Subject: LaSalle County Station Units 1 and 2
License NPF-11, Condition 2.C.(30).(1)
Modification of Automatic Depressurization
System Logic
NRC Docket Nos. 50-373 and 50-374

Attachment

Figure 2-1

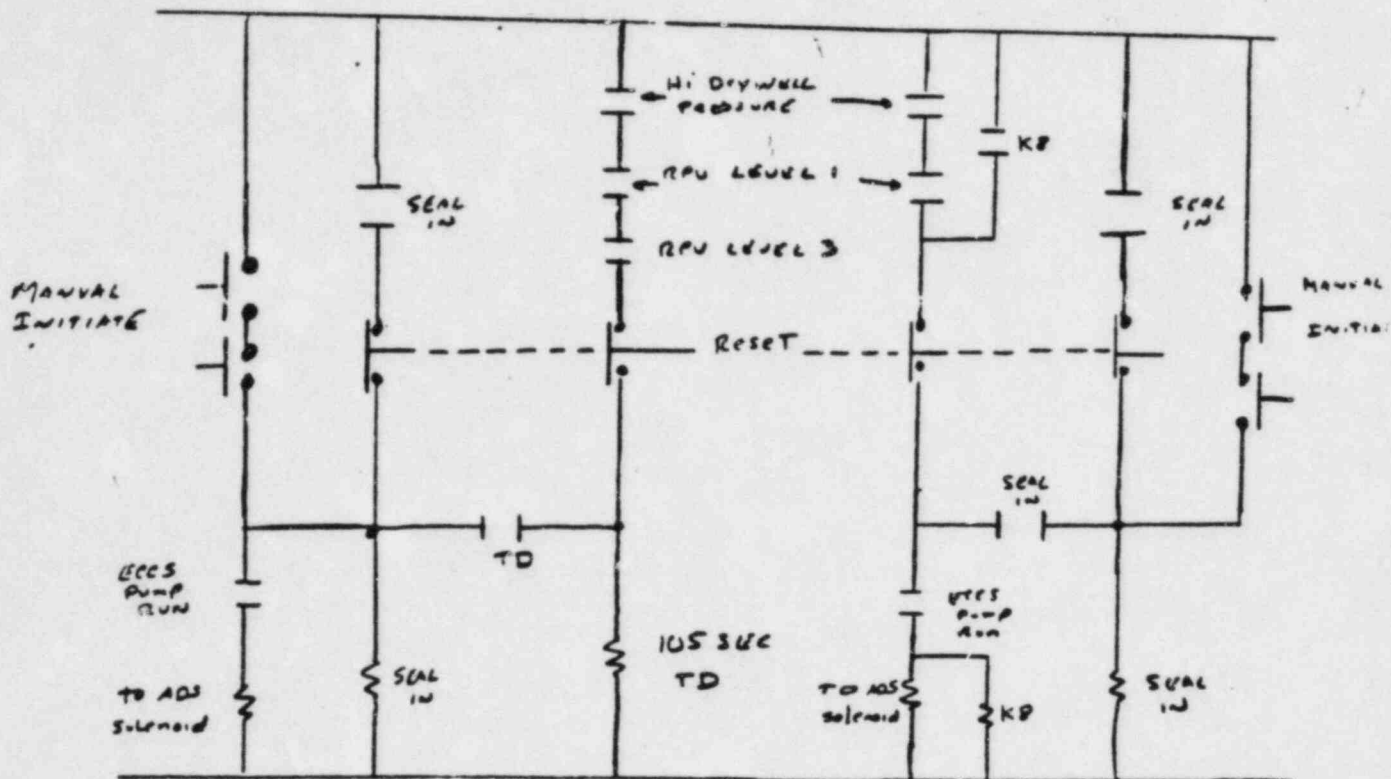
The existing automatic depressurization system logic design (Figure 2-1) requires a LOCA signal consisting of concurrent high drywell pressure and low reactor water level signals in order to actuate the ADS. The high drywell pressure signal is sealed into the initiation sequence and does not reset if the high drywell pressure subsequently clears. When both high drywell pressure and low water level signals have been received, the logic confirms the water level is indeed below the scram water level (to prevent spurious actuations) and starts the 105 second delay timer. The timer is automatically reset if the low water level trip clears before the timer times out. It can also be manually reset. The timer allows the operator time to bypass the automatic blowdown by resetting the logic if the conditions have corrected themselves or if the signals are erroneous. To complete the sequence, the low pressure ECCS pumps are automatically checked to provide some assurance that makeup water will be delivered to the vessel once it is depressurized.

The proposed modification (Figure 2-2) will provide both a bypass of the drywell pressure signal after a set time delay and a manual inhibit function. This will further automate the ADS system by providing automatic ADS initiation, if required, for events such as a break external to the drywell or a stuck-open SRV. The modification also provides the capability for easier operation of multiple SRVs in accordance with EPGs.

The bypass is accomplished by incorporating into the logic design a second "bypass" timer actuated on the same RPV Level 1 trip point as in the current design. The trip picks up a new KX relay which satisfies the RPV Level 1 portion of the logic and starts the new nominal 8 minute time delay relay. This also activates an alarm that the bypass logic has been activated. After the set time delay, the time delay relay contacts located in the drywell signal bypass circuit are closed, affecting the bypass. The existing 105 second timer is then started and the ADS solenoid energized, after runout, provided that at least one low pressure pump in that division is running. When the low water level signal has cleared, or the reset pushbutton is pressed, the bypass timers are automatically reset.

A manual inhibit switch is also included in this modification as shown in Figure 2-2. The manual inhibit switch allows the operator to inhibit ADS operation without repeatedly pressing the reset pushbutton. One manual inhibit switch is to be provided for each division, a standard two-position maintained-contact type switch. Each switch activates a white indicating light and an annunciator to alert the operator of the inhibit action. The pressure relief function and the manual ADS or individual SRV control is not affected by operation of the manual inhibit switch.

The manual initiation portion of the logic is modified as shown in Figure 2-2 such that a running ECCS pump is no longer a prerequisite to activate ADS manually. The seal-in feature in the current design is also modified so that seal-in only occurs after the ADS solenoids are actually energized. This eliminates the possibility of inadvertent depressurization if a low pressure ECCS pump is started and a previous seal-in had not been reset.
